**Subject: Accidental Wastewater Discharge Comment Response Letter
Break of 42" Sewer Force Main at NW 15th Street and I-95
Pompano Beach, FL**

BCEPD Comments & Responses:

Subject: Break of 42" Sewer Force Main at NW 15th Street and I-95 - Restoration Plan

Figure 1: Site Location Map

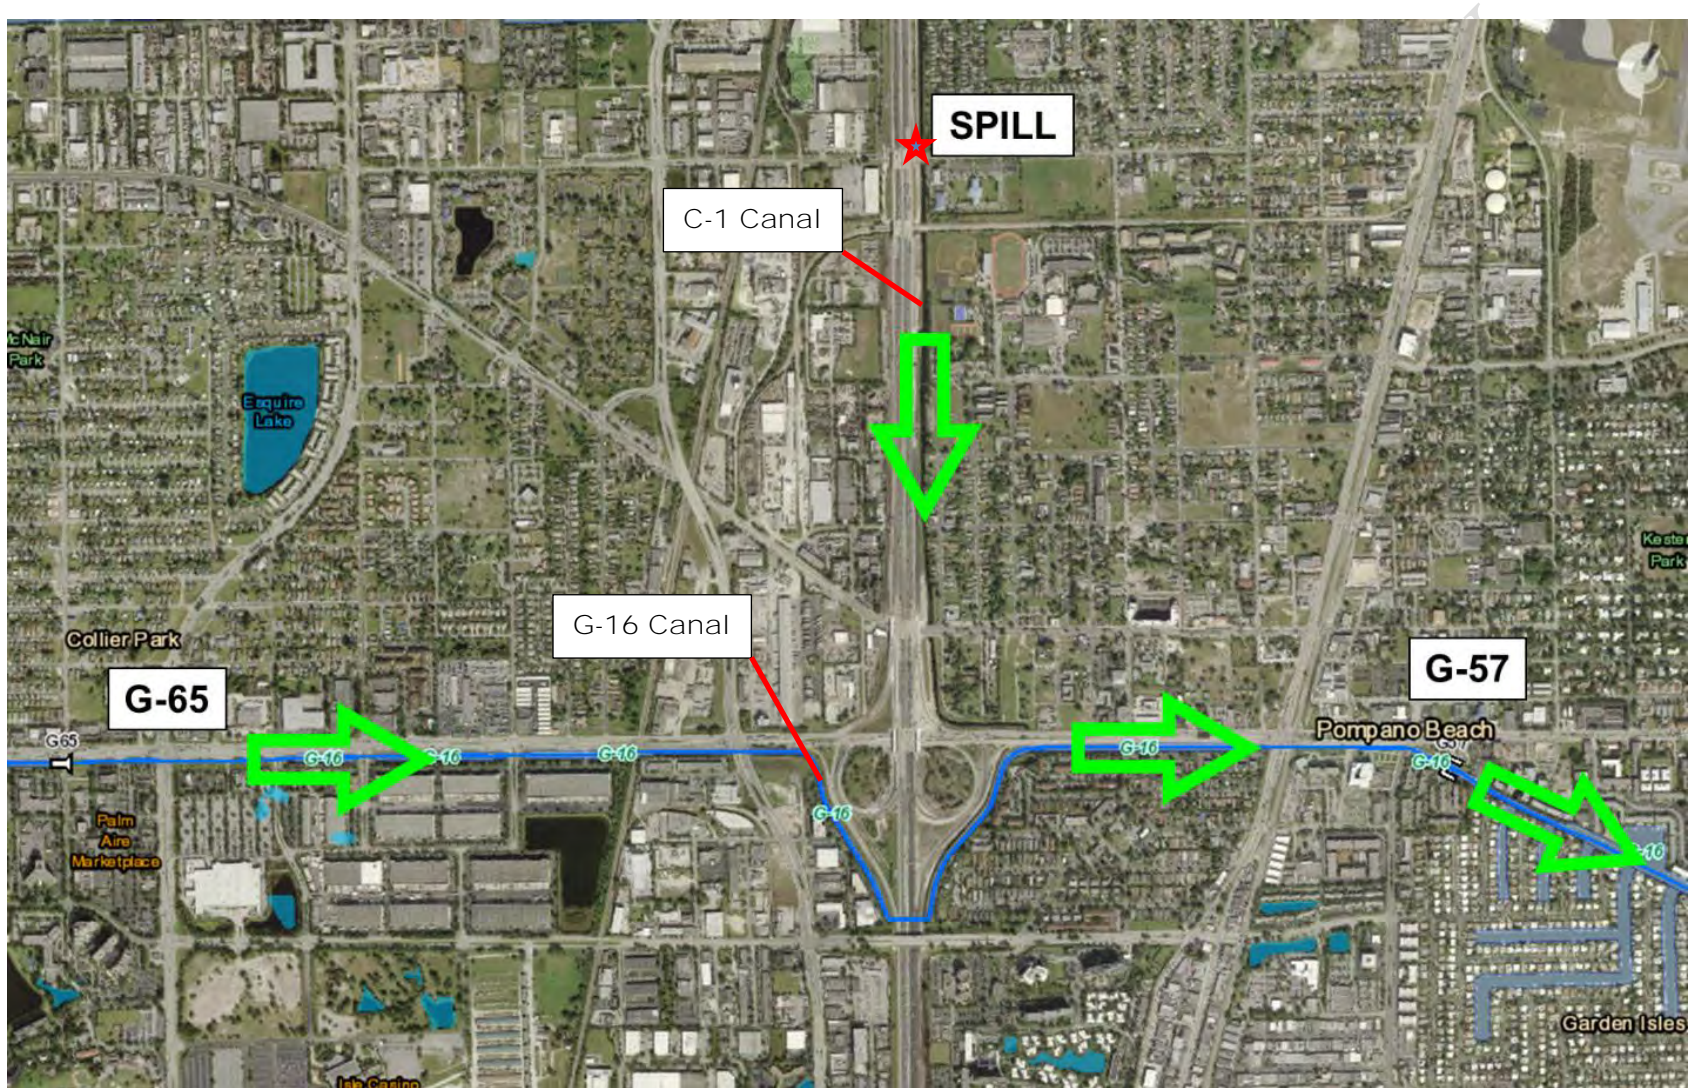
1. Figure 1 of the plan identifies all canals and waterways impacted by the sewage spill. Please advise of any revisions to this figure since January 31, 2019.

1. Figure 1 of the plan identifies all canals and waterways impacted by the sewage spill. Please advise of any revisions to this figure since January 31, 2019.

Based on APTIM's evaluation of the available surface water data collected to date, no revisions are recommended to **Figure 1** Estimated Maximum Extent of Fecal Indicator Bacteria in Surface Water, provided to BCEPD on January 31, 2019.

**C-1 Headwall
Sediment Sampling
Locations**

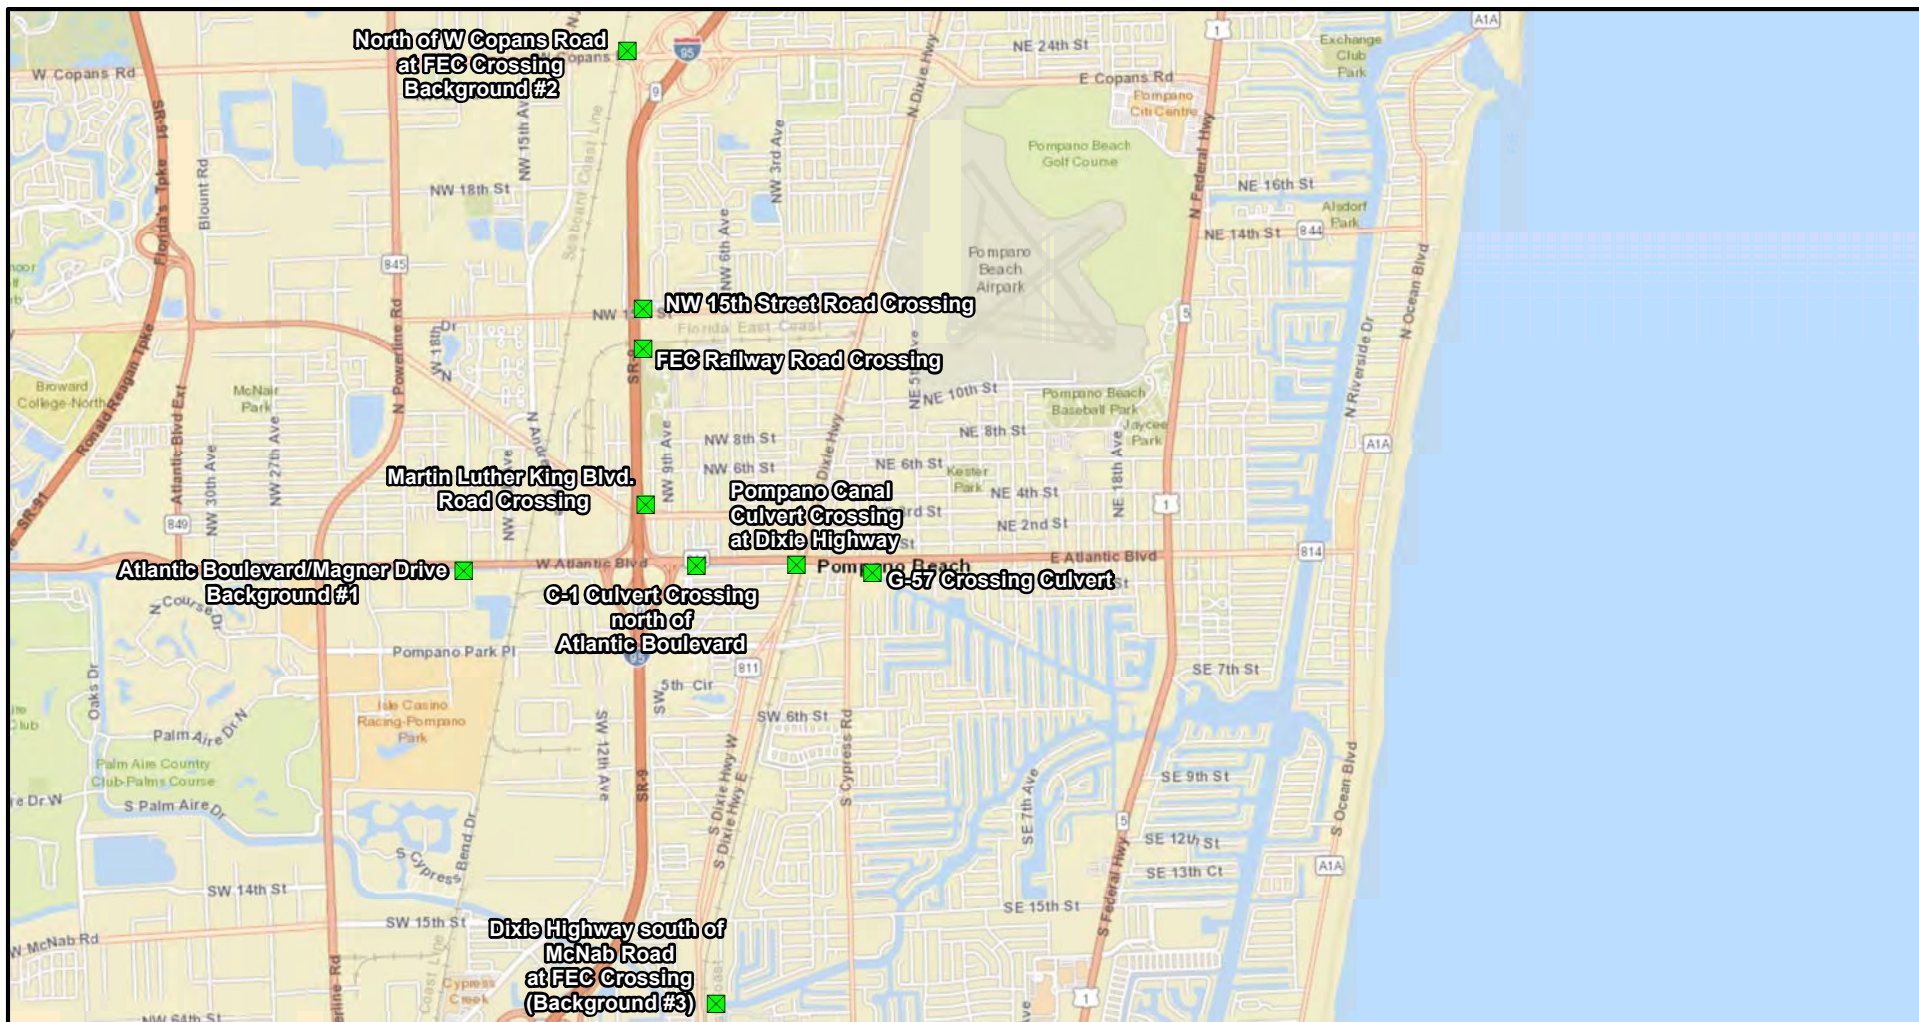
2. Please provide an update on the efforts to determine the amount of sewage sludge/waste accumulated on the bottom of the canals and waterways, including a) the results of the proofs of concept, and b) any coordination with the Florida Department of Transportation (FDOT), the Broward County Water Control District (BCWCD) and South Florida Water Management District (SFWMD) to ensure an accurate determination. Please be advised our agency expects strict adherence to the timelines provided in the January 31 plan for this determination and field verification of the results at all locations identified in Figure 1.

After the sediment collection method had been tested and confirmed, APTIM collected sediment core samples in the C-1 Canal and Pompano Canal. Sediment samples were collected at measured step-outs, across the canal, at six (6) separate upstream headwalls of gates and culverts located in C-1 Canal and Pompano Canal and three (3) additional locations were collected outside of the area of impact to represent background conditions. The locations of the C-1 Canal, Pompano Canal (G-16), and the flood gates & culverts are illustrated on **Figures 1 and 2**, respectively.

A total of nine (9) sampling locations were selected for the initial sediment sample collection event. Those locations were: NW 15th Street Road Crossing, FEC Railway Road Crossing, Martin Luther King (MLK) Blvd. Road Crossing, C-1 Culvert Crossing north of Atlantic Boulevard, Pompano Canal Culvert Crossing at Dixie Highway, G-57 Crossing Culvert, Atlantic Boulevard/Magner Drive (Background #1), North of W Copans Road at FEC Crossing (Background #2), and Dixie Highway south of McNab Road at FEC Crossing (Background #3). The Sediment Sampling Locations (Gate/Culverts) are illustrated on **Figure 2**.
